Independent Review of the Seismic Safety Peer Review Panel Proposal to Shim the Bearings at Pier E2 of the New East Span of the San Francisco -Oakland Bay Bridge

2013 August 06

Our Ref: 2054-RPT-GEN-001-0A

BUCKLAND & TAYLOR

Figure 1: "As Designed" Transmission of Horizontal Seismic Forces at Pier E2

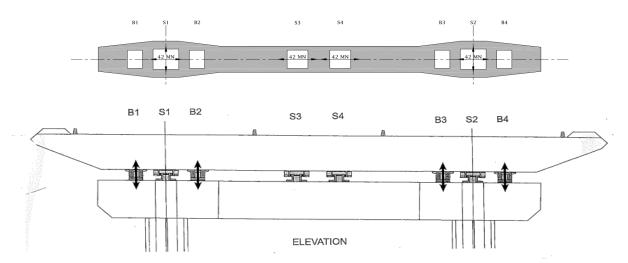
The design seismic load paths maintain the 20 mm longitudinal gaps in shear keys S3 and S4 and the 20 mm longitudinal and lateral gaps in Bearings B1, B2, B3 and B4, thereby engaging only shear keys S1 and S2 in both directions and shear keys S3 and S4 in the transverse direction. This provides a total seismic horizontal connection capacity of 84 MN longitudinally and 168 MN in the transverse direction.

The horizontal seismic demand on the shear key bases at Bent E2 comprises both shear and moment, which are resisted by the friction (coefficient 0.67) and clamping forces created by 48 bolts of 3 inch diameter (ASTM A354 Grade BD) pretensioned to 68% of their ultimate stress of 140 ksi (965 MPa) or about 3 MN per bolt.

The equivalent demand between the shear key top sections and the steel box superstructure at Pier E2 is resisted by the friction (coefficient 0.50) and clamping forces created by 80 bolts of the same diameter and pretension.

The lack of transverse clearances at the shear keys will cause some minor thermal stressing of the top beam of bent E2 and the transverse beam connecting the box girders for temperature differentials between superstructure and bent.

Figure 2: "Present" Transmission of Horizontal Seismic Forces at Pier E2

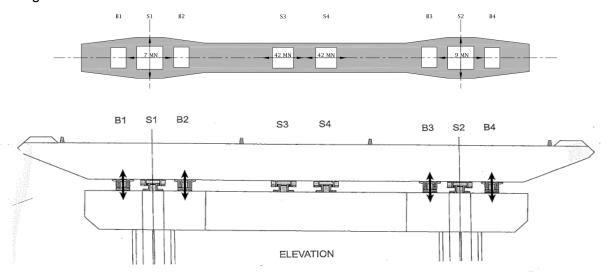
All of the details of the "current" situation at Pier E2 are not precisely known, but it is known that at shear keys S1, S2 all existing unbroken ASTM A354 Grade BD anchor bolts have had their pretension tensile stress reduced to $0.45\,f_u$ and the two outer longitudinal rows of anchor bolts on the bases have been detensioned and cut flush with the top of baseplate to permit installation of the steel post tension saddles.

After discounting the broken anchor bolts and those removed in the saddle zone, shear key S1 has 12 functional anchor bolts out of an original 48 and S2 has 16. These anchor bolts are tensioned to $0.45\,f_u$ instead of $0.68\,f_u$. By proportion, the approximate horizontal load capacity of these shear keys has been reduced to:

The "present" configuration of bearings and shear keys at site is unable to mobilize sufficient longitudinal and transverse resistance to handle the demands of the 1500 year ground motions.

Figure 3: "Proposed Temporary" Transmission of Horizontal Seismic Forces at Pier E2

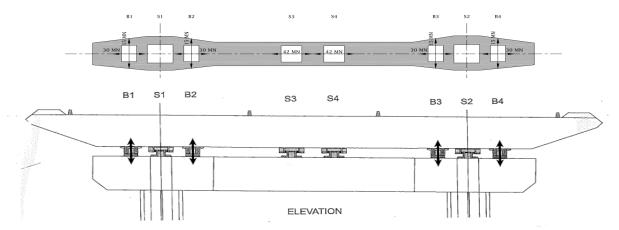
The "proposed temporary" combined horizontal load capacities of the bearings and shear keys at Pier E2 exceed the seismic demands in both the longitudinal and lateral directions.

The precise distribution of the horizontal forces in the transverse direction between the bearings and shear keys is indeterminate. However, the overall demand over capacity ratio in the transverse direction is only about 0.6, so that significant variations above the average demand on any one component can be tolerated.

Some small thermal forces may occur in the crossbeams of the pier and superstructure at Pier E2 due to differential temperatures between the superstructure and substructure.

Taking into account the local high steel-to-steel bearing stresses identified in the Finite Element Analyses of transverse loadings on the bearings, the shim plates may experience yield strains in a seismic event. The use of high yield strength shim material should be considered.

We conclude that the bearings and shear keys are well able to handle the 1500 year seismic demands with the bearings in their shimmed configuration during the "proposed temporary conditions".

Figure 4: Steel Saddle Retrofit of Shear Keys S1, S2

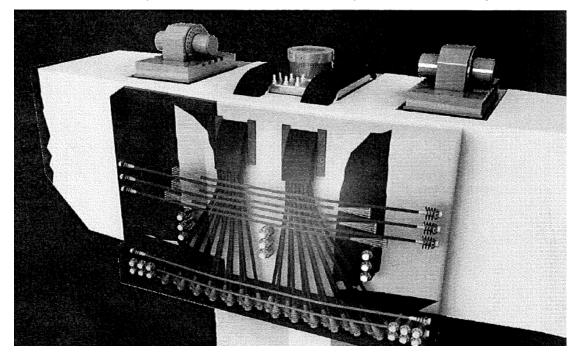
The "revised final design" capacities and load paths replicate the "as originally designed" stage, except that the actions of the anchor bolts connecting the bases of shear keys S1 and S2 to the crossbeam of Pier E2 are replaced by a new array of post-tensioned cables anchored on the faces of the Pier E2 crossbeam and pulling downwards on steel yokes located over the shear key baseplates; see Figure 4.

Once these post-tensioned steel saddle retrofits have been completed at shear keys S1 and S2, then the shims will be removed from bearings B1, B2, B3 and B4.
